IFWG on Helmet R22-06

Brief Reaction / Discussion of rev4

Reaction / Discussion of Draft R22-06 rev4

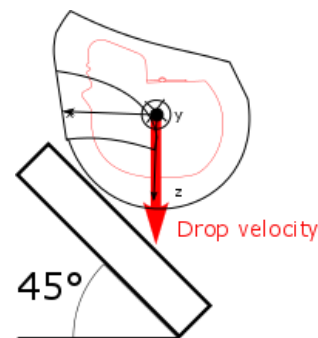
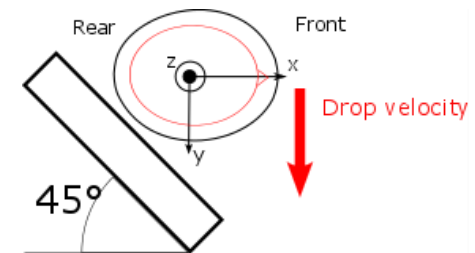
- Free drop against 45° inclined anvil
- Oblique impacts : RotX, RotY, **RotZ is essential as well**
- Diameter of anvil : 130 cm or **150 cm**
- 8m/s ; **HIC 1200 ; MAA 10,4 rd/s² BRIC 0,78 or 0,6 or 0,75. :**
linear loading must be considered as well.
- How to Monitor Model based injury criteria
(80% AIS2+)
